Technical Note

THE FITZROVIA

RESIDENTIAL LIFT PROPOSAL

BL5251/lr/227pdp 19.04.24

Figure 1: Proposed Core Arrangement

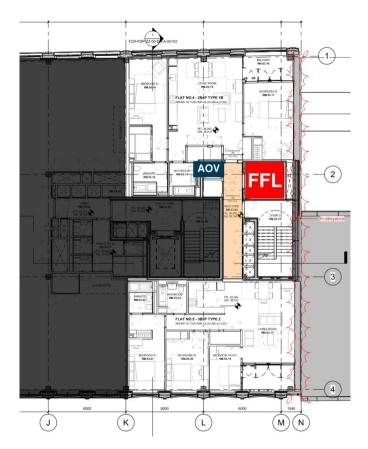
However, the scheme has now reached an impasse where the lift supplier (Fujitec) cannot certify the lift as an evacuation lift that can be used for independent evacuation and also as a firefighting lift for a number of reasons as described later in this note. It is therefore proposed to provide a code compliant firefighting lift in line with the recommendations of Building Regulations guidance as agreed with our Building Control consultant Sweco via email dated 29 February 2024 in which they confirm that this proposed fire strategy would follow the principle of means of escape from residential units as described within BS 9991. As a result, the fire statement approved on 5 December 2023 (Condition 42 - LPA ref. 2023/0075/P) has been updated by way of this document and submitted to re-discharge Condition 42. The details of the amendments are set out below and the updated fire statement is being submitted with this application."

The statement is correct as the firefighting lift can be used for evacuation if required by the Fire Service. However, it cannot be used for independent self-evacuation before the fire service arrive as per the intent of the London Plan and emerging guidance. This is because of the following reasons:

- As per Fujitec's correspondence the lift cannot be certified in accordance with EN86-71 as a firefighting lift upon detection goes to ground and waits for fire service control.
- To comply with BS 9999 evacuation lifts should have a trained member of staff on site to drive the lift. Given the size of the development there is no on-site concierge to operate the lift. This will be the case for the majority of developments across the country and is not unique to this scheme. Therefore, as per Fujitec's correspondence it cannot be certified as an evacuation lift under current guidance.

It is therefore proposed to provide a fully code compliant firefighting lift and no evacuation lift or evacuation functionality as part of the firefighting lift. This has been updated in the fire strategy and has been agreed with Building Control as noted in the Introduction.

Not providing an evacuation lift still meets the functional requirements of the Building Regulations as: -

- Occupants requiring assistance are able to reach the stair within a compliant single direction travel distance. The stair will provide a safe place of refuge.
- A refuge and associated emergency voice communication (EVC) point will be provided which is above the recommendations of guidance for a residential building.
- There is only a total of 8 apartments in the building. Therefore, the number of occupants escaping would be limited and should not disrupt firefighting operations.
